Office Action Summary	Application No. 10/722,729	Applicant(s) BRIGHT ET AL. 	
	Examiner George Nguyen	Art Unit 3723

DETAILED ACTION

2. Claims 1-12 are rejected under 35 U.S.C. 103(a) as being unpatentable over Chiou et al.'5,873,769.

FIG. 5

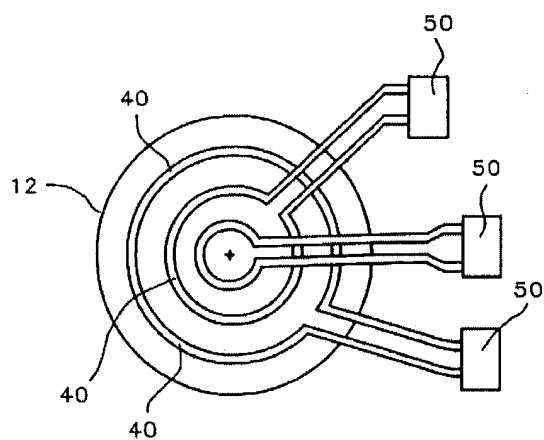
With reference to Figures 4-5, col. 4, line 48 to col. 5, line 20, Chiou discloses a temperature compensated chemical mechanical polishing to achieve uniform removal rate. Please note that col. 5, lines 30-35, Chiou discloses a thermal gradient between the inner circular segment 61 and the outer circular segment 65. Furthermore, in col. 5, lines 58-67, Chiou inherently teaches a temperature measuring means and a controller to adjust the temperature of the heat transfer system in order to control the wafer temperature.

FIG. 5 shows methods and apparatus of heating the concentric heating elements 40 in greater detail. The concentric heating elements 40 can be electric heating elements in the wafer carrier 12 supplied by independent electrical power sources 50. The concentric heating elements 40 can be tubes in the wafer carrier 12 through which heated or cooled liquid from independent sources 50 flows.

FIG. 4

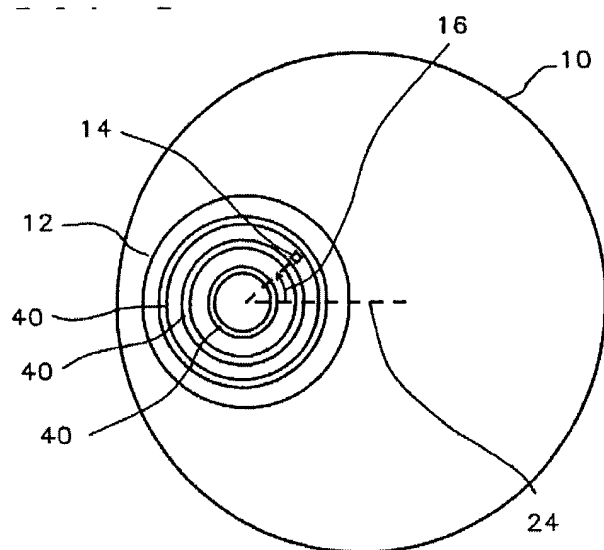
As shown in FIG. 4 a number of concentric heating elements 40 are placed in the wafer carrier so that the temperature of circular regions of the wafer carrier, concentric with the center of the wafer carrier, can be independently controlled. The temperatures are adjusted so that the temperature at the center of the wafer carrier is the greatest and decreases with increasing distance from the center of the wafer carrier to the edge of the wafer carrier, which is at the lowest temperature. With this temperature variation the same wafer material removal rate, independent of either distance from the center of the wafer or position angle, can be achieved over the entire wafer surface of the wafer as shown by the top curve 74 in FIG. 3.

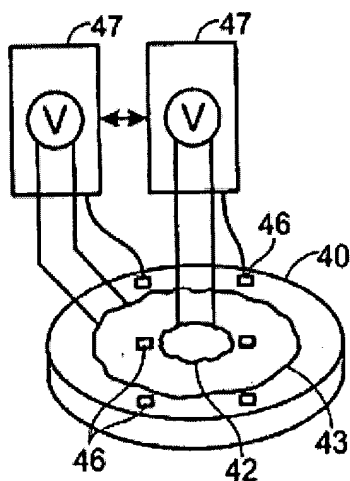
FIG. 8 shows a diagram of the platen 10 and the wafer carrier 12 showing circular segments, 61, 63, and 65 of the platen and circular segments, 41, 43, and 45 of the wafer carrier. It can be seen from FIG. 8 that the temperature of each circular segment of the platen affects the removal rate for a position angle 16 of 0 and $360^\circ - \theta$. Next the temperature of circular segments of the platen, 61, 63, and 65 are adjusted so that the temperature of the inner circular segment 61 of the platen corresponding to position angle of 0° or 360° is the highest, the temperature of the outer circular segment 65 of the platen is the lowest, and the temperature of the circular segments progress between these extremes in a regular progression.

The temperature adjustment of the platen circular segments described above superimposed on the temperature adjustment of the wafer carrier circular segments described above produces a removal rate which is nearly constant over the entire surface of the wafer, as shown by curve 84 in FIG. 6B. The actual variation of the normalized removal rate of material from the wafer is less than about 4% from the highest removal rate to the lowest removal rate.
